Access Compliance Report Public Rights-of-Way (Curb Ramps)

Intersection ID: 10006563 Main Street: SHADE_VALLEY_RD Cross Street: OAKHURST_COMMONS_DR Location: SW ADA ID: 4D949ABB9244 Ramp Type: Directional1 Initial Pass/Fail: Fail **Overall Compliance: No** Severity Score: 13.75

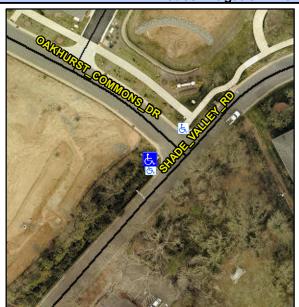
Possible Solution		
Possible Solutions:	Compliand	
Remove & Replace Entire Ramp.	N/A	R
•	Yes	R
	No	Ra
	No	Ra
	N/A	FI
	N/A	FI
Surveyor Notes:	N/A	FI
N/A	N/A	La
	N/A	La
	N/A	La
	N/A	La
PROW/ADA:	N/A	La
R304.2.2, R304.5.3	N/A	Sł
·	N/A	G
	N/A	G
	N/A	Pa
		Χ
		Χ
		Χ
		Χ
	N/A	Ra

Field Measurements/Component Compliance								
Compl	iance Description	Data	Comp	liance Description	Data			
N/A	Ramp Length (in)	78.0	N/A	Grade Break?	N/A			
Yes	Ramp Width (in)	64.0	N/A	Grade Break Slope (%)	0.0			
No	Ramp Slope (%)	8.7	N/A Grade Break XSlope (%)		0.0			
No	Ramp XSlope (%)	2.7						
N/A	Flare Type LT	N/A	N/A	Flare Type RT	N/A			
N/A	Flare Slope LT (%)	N/A	N/A	Flare Slope RT (%)	0.0			
N/A	Flare Traversable LT?	N/A	N/A	Flare Traversable RT?	N/A			
N/A	Landing Length (in)	0.0	N/A	DWS Provided?	N/A			
N/A	Landing Width (in)	0.0	N/A	DWS Contrast?	N/A			
N/A	Landing Slope (%)	0.0	N/A	DWS Length (in)	N/A			
N/A	Landing X Slope (%)	0.0	N/A	DWS Full Width?	N/A			
N/A	Landing Curb? (Y/N)	N/A	N/A	DWS Offset LT (in)	N/A			
N/A	Shared Landing?	N/A	N/A	DWS Offset RT (in)	N/A			
N/A	Gutter Ponding?	0.0	N/A	Gutter Slope (%)	N/A			
N/A	Gutter Lip Ht (in)	2.0	N/A	Gutter X Slope (%)	N/A			
N/A	Painted X Walk1?	No		Road Slope (%)	2.5
